## Road Safety Assessment (RSA)

SR 84 – Niles Canyon Corridor  
Alameda Co., California  
May 2012

Figure 21: Modern roundabouts have fewer conflict points and fewer crashes

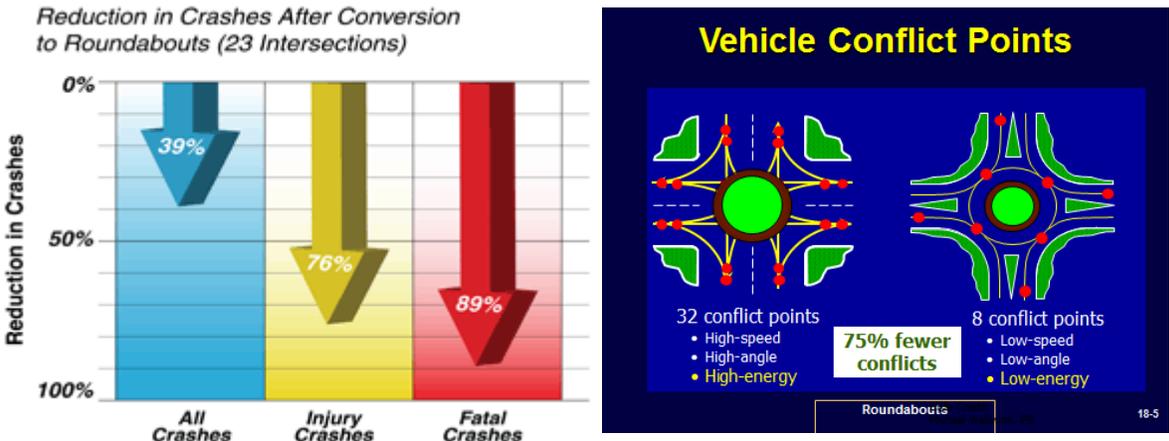
*Signalizing the Water Temple intersection might help reduce some of the queuing, however the team believes an even more effective choice would be to consider a modern roundabout in these locations.* Reduction or elimination of queuing at the Water Temple and near the school in Sunol has the potential for not only improving safety by crash reductions but also by reducing the informal short cuts during queues through Sunol, especially near the school.

Modern roundabouts not only are “greener,” but also quieter, reduce conflict points, slow speeds, are capable of handling farm equipment, can handle a higher number of vehicles and are one of the top proven safety countermeasures for enhancing safety.
